ATTENTION NOTICE

We suggest that all operators with Virtual Rabbids UHD should make the following modification to the headset covers:

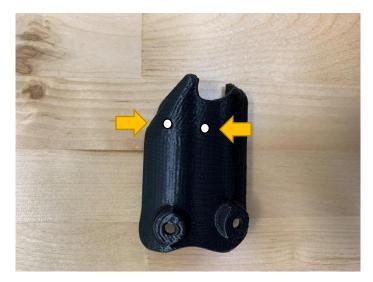
REASON FOR THE CHANGE: Some operators have experienced intermittent laggy video on the top monitor and loss of video in the headsets. This has been determined to be caused by either a loose or failed All-in-One cable. This modification will remove the possibility of a loose cable at the headset connection.

1. Remove the cable cover from the headset cover by removing the two screws.

2. Drill two holes in the area shown below, using a 1/8" drill bit and drill driver.

3. Thread a small cable tie through one hole, under the All-in-One cable and back up through the opposite hole. Do not tighten the cable tie before reading the next step.

4. Refasten the cable cover screws prior to tightening the cable tie.

1. Once the cable tie is tightened, remove the excess length of cable tie with a pair of side cutters. Modification is complete.
